CCL Ref: 14649-050721-haynes

Sean Haynes
Wooing Tree Development Partnership LP

Response to EPA Matters

Figure 1: Parking Spaces to be Removed to Create Queuing Space

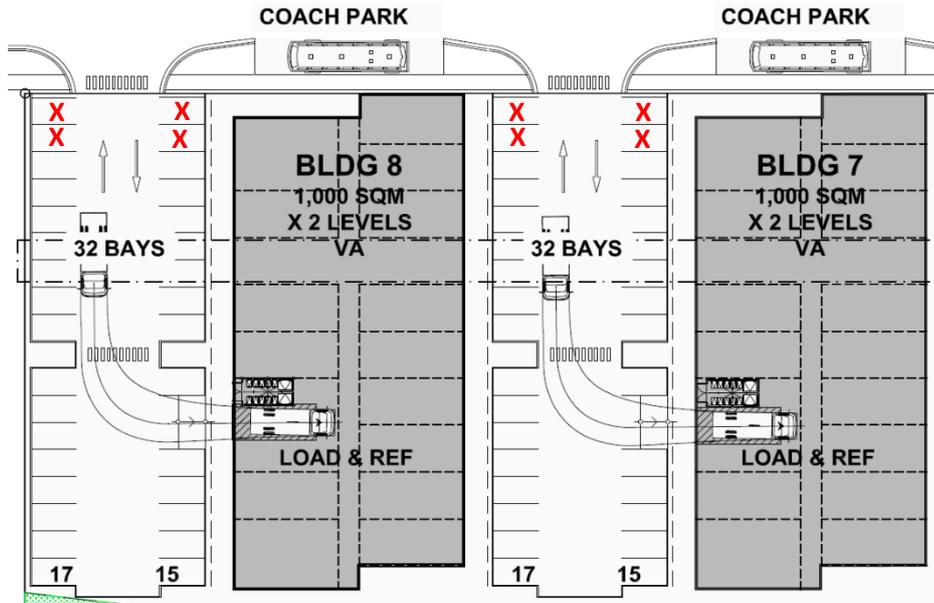
Matter 9: The traffic assessment identifies shortcomings with respect to turning areas and queuing space in car parking for the non-residential aspect of the development. Please provide details of the solution to those shortcomings along with revised plans

The Transportation Assessment (paragraph 9.4.16) set out that *"in respect of queuing space, the District Plan requires 6m of queuing space for a car park with 20 to 100 spaces and 15m for car parks of larger capacity. Queuing space is measured from the site boundary to the point where conflict with vehicles in the site may arise. The majority of the car parking areas do not provide the required amount of queuing space. Waiting vehicles will therefore obstruct either the adjacent footpath or the adjacent traffic lanes."*

We show below the parking spaces that would need to be removed to achieve the required queuing space.

It can be seen that in total, 28 spaces should be removed to achieve a complying queuing space.

Removal of 28 spaces to achieve a complying queuing space will therefore mean that the site continues to meet the parking space ratios of the District Plan.

That said, the issue of queuing space arises because of the need to ensure that an entering vehicle is not obstructed by another vehicle moving to or from a space. One relevant and practical mitigation technique is therefore to reserve those spaces within the queuing space (as identified above) for staff only. Staff arrived prior to customers arriving, and depart after the bulk of customers have departed, meaning that it is very unlikely that a staff vehicle will be manoeuvring at the same time as a customer vehicle enters. Consequently, it would be possible to retain the spaces shown above and to mark them for staff only.

Figure 5: Parking Spaces to be Removed to Create Turning Area

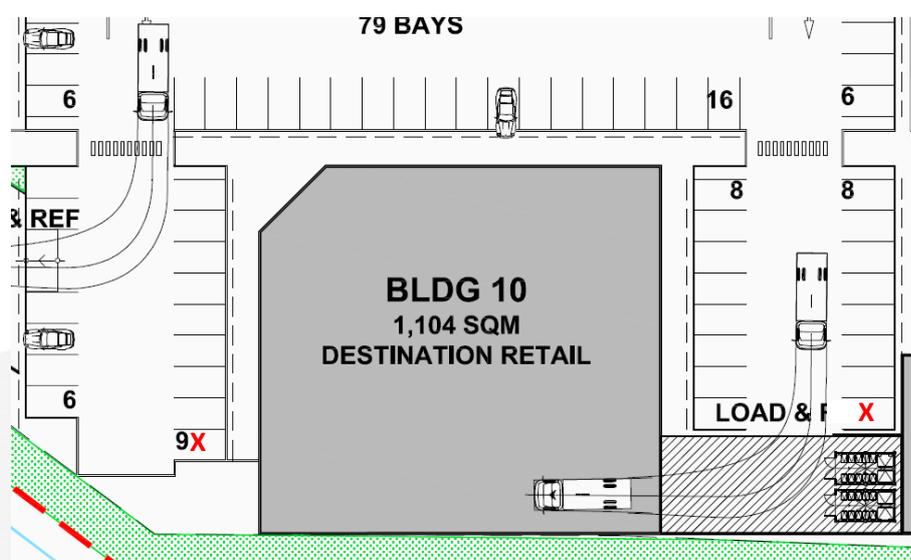
With regard to turning areas, this issue only arises in the car parks to the east and west of Building 10, where it is possible that a driver will enter the car park and find all spaces occupied (meaning they would then have to reverse for an extended distance, and over a marked zebra crossing to be able to turn their vehicle). We recommend that two spaces are removed to create a turning area, as shown below.

This removal of 2 spaces reduces the on-site parking to 283 spaces (taking into account the loss of spaces to providing queuing space) which continues to meet the required parking ratio of 281 spaces.
